DEVELOPMENT ASSESSMENT REPORT	
Application No.	DA/2020/0134
Address	42-46 Hutchinson Street, St Peters
Proposal	Demolition of existing warehouse building and construction of new mixed use development (dwellings and commercial tenancies) plus basement parking, landscaping and associated works.
Date of Lodgement	27 February 2020
Applicant	Group Architects (formerly Brenchley Architects)
Owner	Mama Ka'z Pty Limited
Number of Submissions	19
Value of works	\$4,393,400.00
Reason for determination at Planning Panel	Development to which <i>State Environmental Planning Policy No 65</i> applies and is 4 storeys in height 10% breach to LEP Development Standard (Height of buildings) Number of submissions
Main Issues	Building height, site servicing and pedestrian through site link
Recommendation	Deferred Commencement Approval
Attachment A	Recommended conditions of consent
Attachment B	Plans of proposed development

This report is an assessment of the application submitted to Council to carry out demolition of an existing warehouse building and construction of a new mixed use development (dwellings and commercial/ business tenancies) plus basement parking, landscaping and associated works at 42-

PEDESTRIAN LINK LANDSCAPING

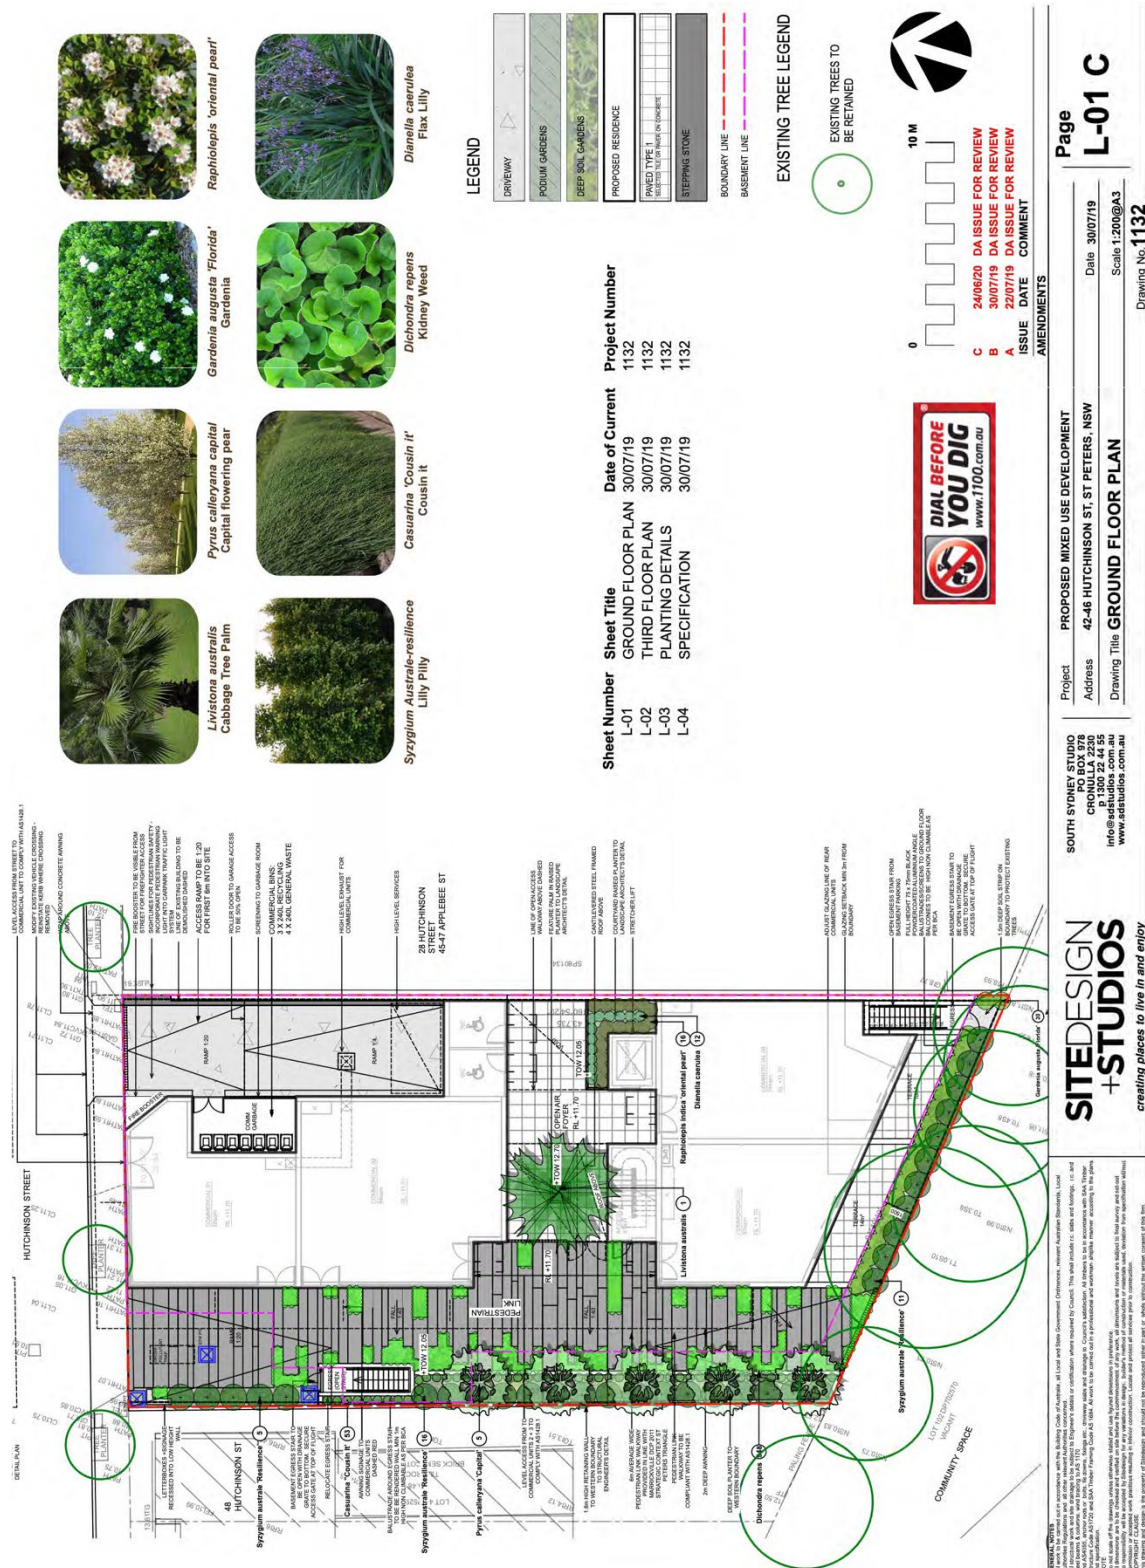
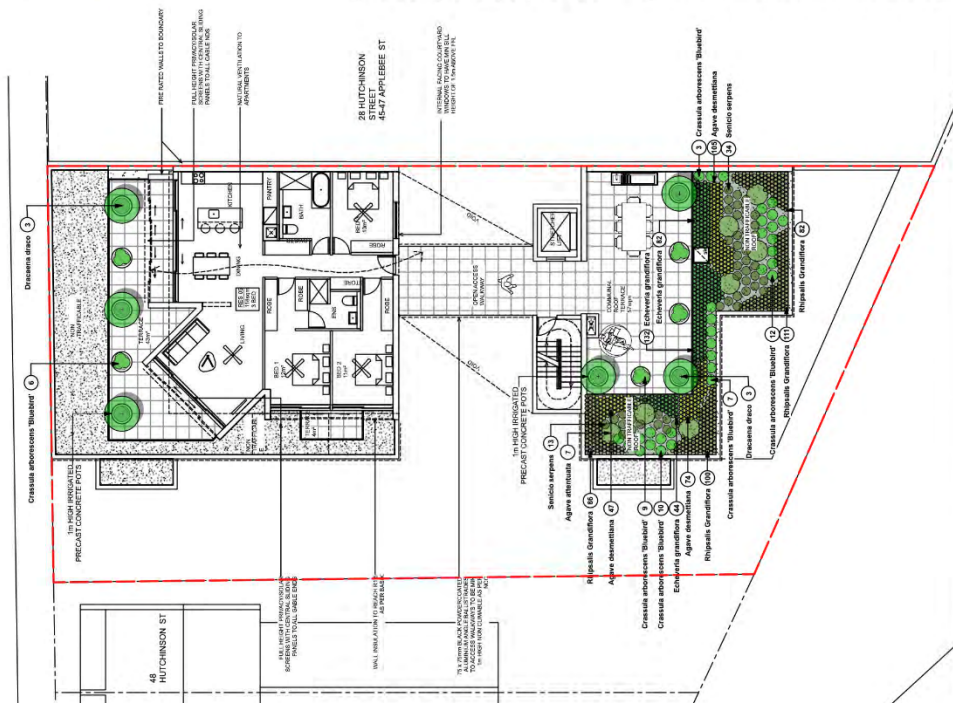
- a. The raised planter that is shown along the rear western side boundary on the Landscape Plan prepared by Site Design + Studios (Dwg L-01 C) and dated 24/6/20, must be deleted. The trees proposed must be planted in deep soil (no planter) and all retaining must be along the boundary alignment.

- b. The *Pyrus calleryana* 'Capital' trees must be planted a minimum distance of 1.5 metres from the side boundary. The garden bed must be widened where the trees are located to allow for adequate clearance to paving.

- d. The plans must show a light weight fence (post and rail) with isolated piers/posts and no strip footings along the rear boundary.

Figure 3: Extract from Figure 25.6 in St Peters Triangle Masterplan relating to building heights - site outlined in red (source MDCP 2011)

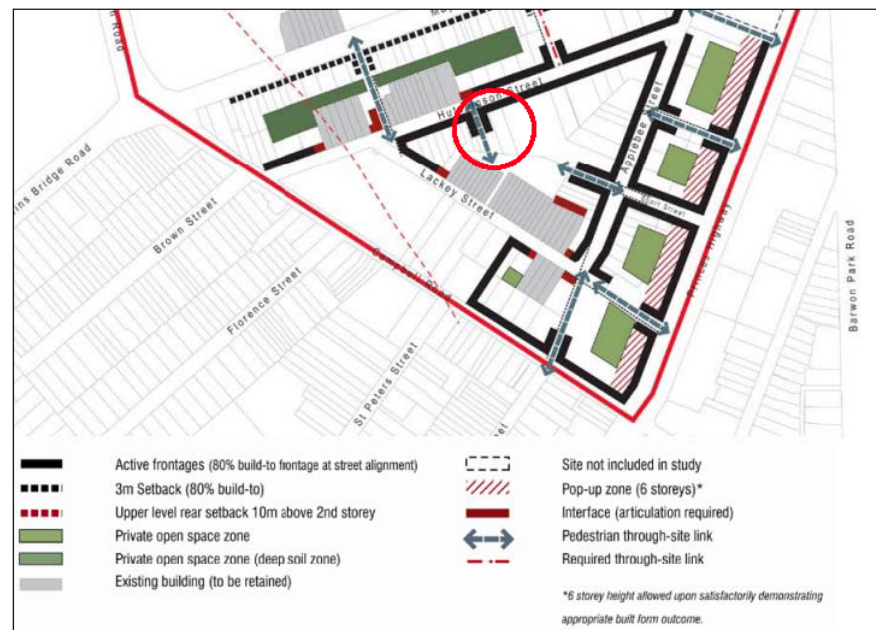
The proposal is generally consistent with Control C23 and Figure 25.6 of MDCP 2011 (see **Figure 3** above) as a through-site link is proposed on the site's western boundary, linking Hutchinson Street with the open space to the rear of the site. The proposal is built to the Hutchinson Street boundary and also incorporates an active presentation to the proposed through-site link, as required. If the through-site link is included as active frontage (given its busy communal nature), the proposal have a 70.6% active frontage, and would be closer to achieving compliance.

Figure 4: Layout of No. 53 Lackey Street (source: Domain)

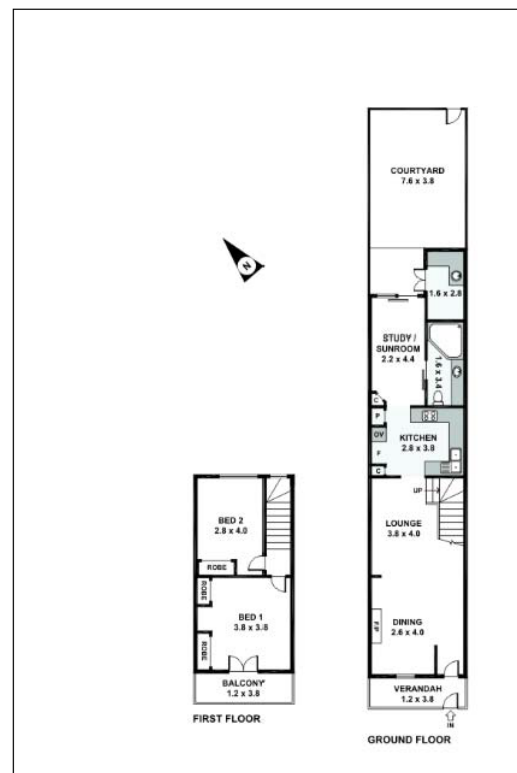
At 9am on 21 June, the proposal will create minor additional overshadowing but the additional impacts do not affect areas of private open space or windows apart from approximately half of a rear door at ground level at No. 53 Lackey Street. Brenchley Architects have reviewed this minor additional impact and have advised that it is not associated with the part of the proposed development which exceeds the maximum 14m height standard. To this end, even if the proposal were amended to achieve full compliance with the maximum height standard, this door would remain affected.

Furthermore, as can be seen in the floorplan below in **Figure 4**, the affected door relates to a study/sunroom and not a living room. To this end, the proposal does not affect the living room of the property and is acceptable with respect to Control C2.

Figure 5: Proposed western elevation, showing the adoption of a stepped built form which assists in minimising the visibility of the upper levels and ensures a transition in scale to the property to the rear (source: Brenchley Architects)

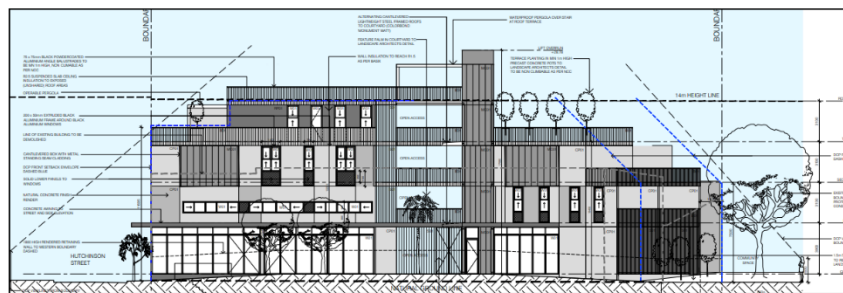
Figure 5 below shows the manner in which the building has been stepped, as per the building height plane control in MDCP 2011, so that the upper level/s are recessive in form and have minimal visibility from nearby public domain. **Figure 6** shows the setback adopted from the west, to provide a transition to the adjoining dwellings.

Ground Floor Plan Excerpt – additional 24sqm GFA highlighted

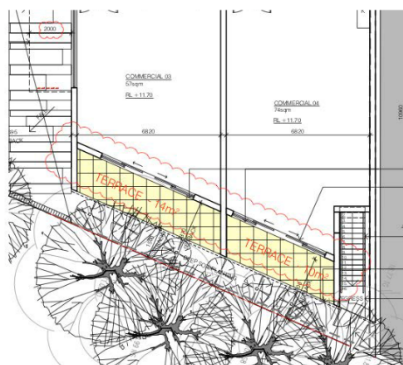
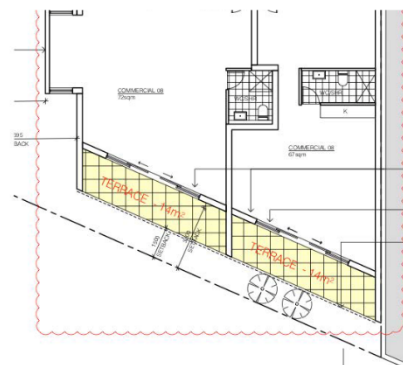
The inclusion of the rear commercial terraces into the GFA calculation adds an additional 52sqm resulting in an FSR of 1.36:1, 4% over the 1.3:1 maximum under the MLEP 2011

This proposed non-compliance is minimal in nature, and does not result in any increase in the building bulk. The increase of GFA is based on the interpretation of the proposed privacy screens being considered solid enclosing walls. The proposal would be compliant were these screens removed. In this instance the amenity benefit to the surrounding residential properties provided by these privacy screens outweighs the numerical non-compliance.
